EXHIBIT 1 DESCRIPTION OF MODIFICATION

Raytheon Company ("Raytheon") proposes to modify license WL2XMV to permit a market trial of its Skyler radar and to make certain changes to technical specifications of the license. The proposed changes are listed below:

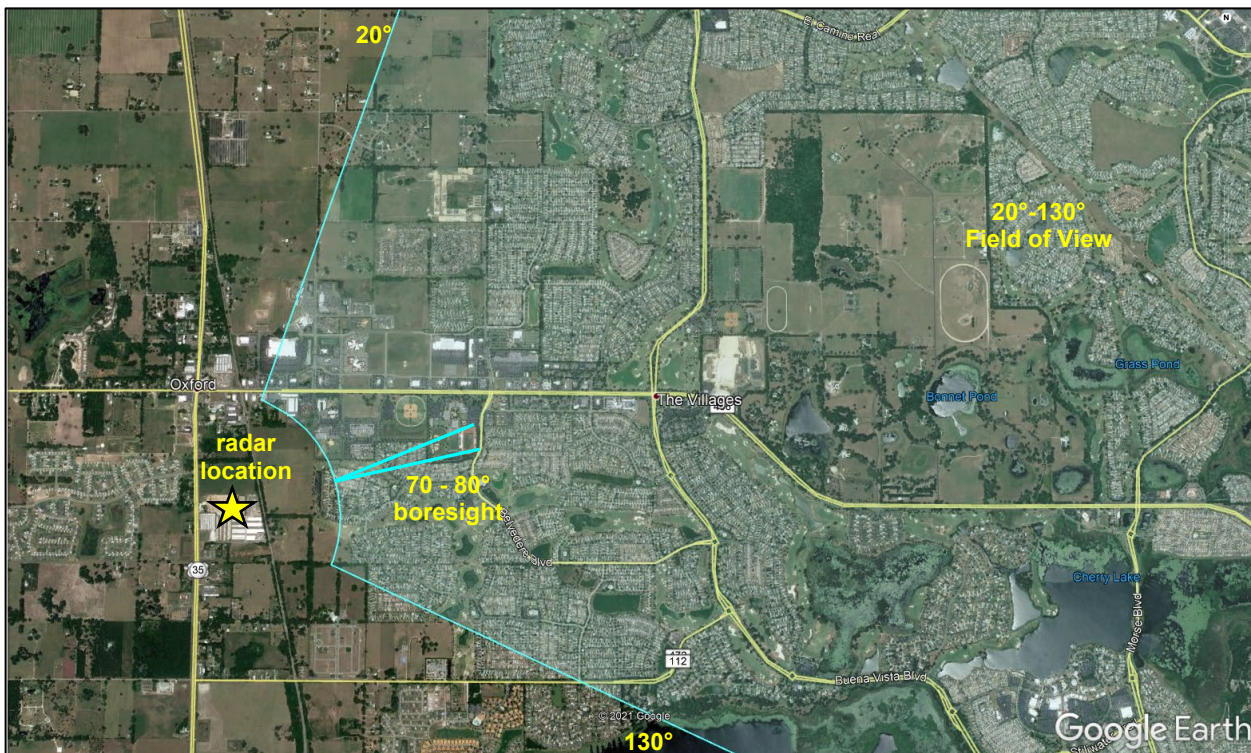
- Modify the antenna height to 85' AGL; and
- Modify Condition 5 of the license to change the azimuth coverage and boresight as follows:

"The direction of antenna boresight must be set between 70–80 deg such that azimuth coverage must contain between 20 and 130 deg reference to true north."

Raytheon proposes a radar boresight between 70–80° to permit adjustments if there are obstacles in its path such as trees and buildings. The expanded azimuth coverage is required to address the flexible boresight.
